**Reference: Railroad Diversion Channel  
Amendment to Preliminary Design Report**

*RAILROAD DIVERSION CHANNEL  
PRELIMINARY DESIGN REPORT  
AMENDMENT*

*PROJECT NO. 81760038*

Figure No.  
 3.1  
 Title

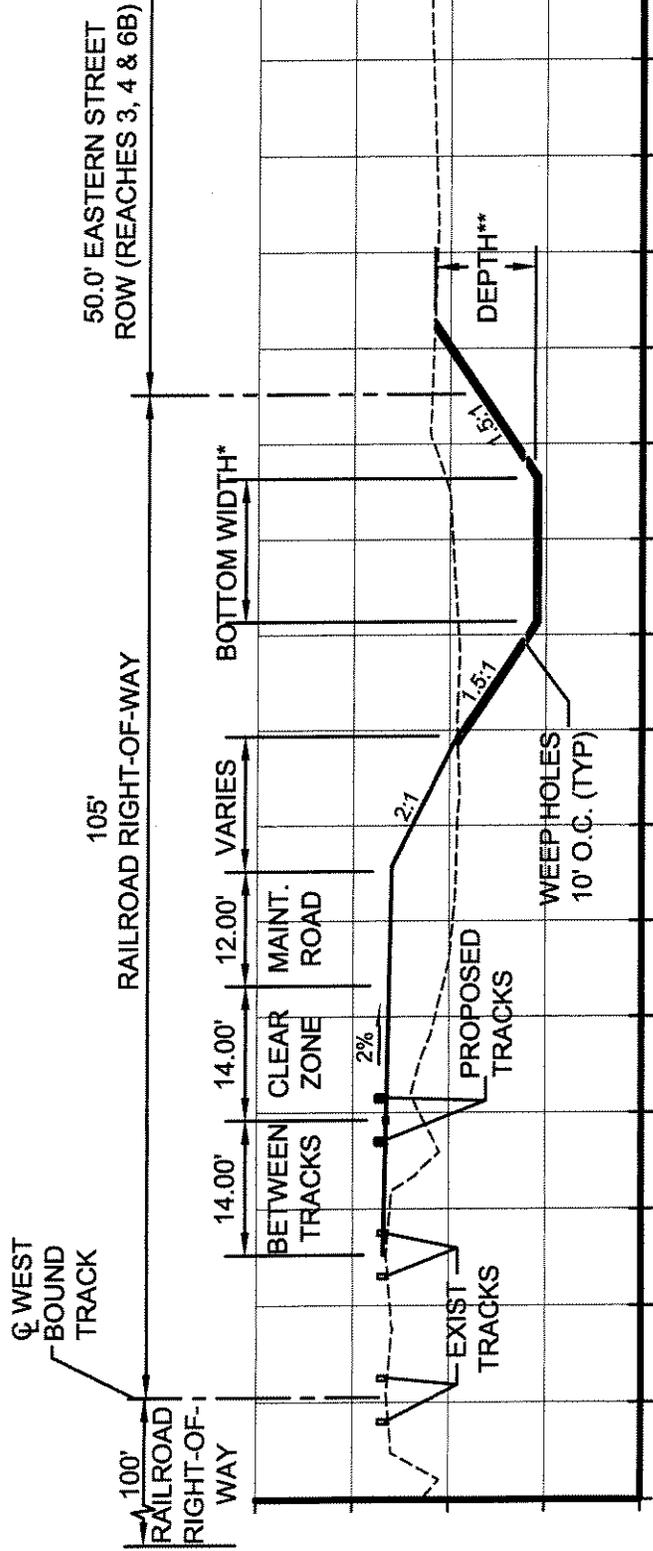
This allows the typical sections for the concrete-lined channels to be reduced, which will mitigate utility and roadway conflicts, specifically through Reaches 1C, 2, 3, 4, 5A, 5B, 6A, 6B and 6C. Channel side slopes for concrete-lined channel is recommended to be 2:1 (H:V) and the minimum bottom width of 8 feet specified. The side slopes can be adjusted to 1.5:1 (H:V) to maintain a trapezoidal typical section.

Concrete-lining is utilized in Sub-reach 1C through Sub-reach 6C. Longitudinal slopes and channel geometry are set to insure stable flows (Froude Number lower than 0.85 or greater than 1.15). One drop structure is needed in Reach 3 and an energy dissipater will be required at the downstream end of Reach 6C. The alignment for Sub-reaches 5B and 6A swings the channel around the proposed Airway Avenue underpass of the railroad tracks, which lowers the longitudinal slope and transitions the hydraulic properties to an unstable flow regime with the Froude Number of 1.0. Additional freeboard will be required for these two (2) Sub-reaches.

REACH	BOTTOM WIDTH*	DEPTH**
3	8.0'	6.0'
4	15.0'	7.4'
5A	26.0'	5.7'
6B	12.0'	6.4'
6C	20.0'	6.3'
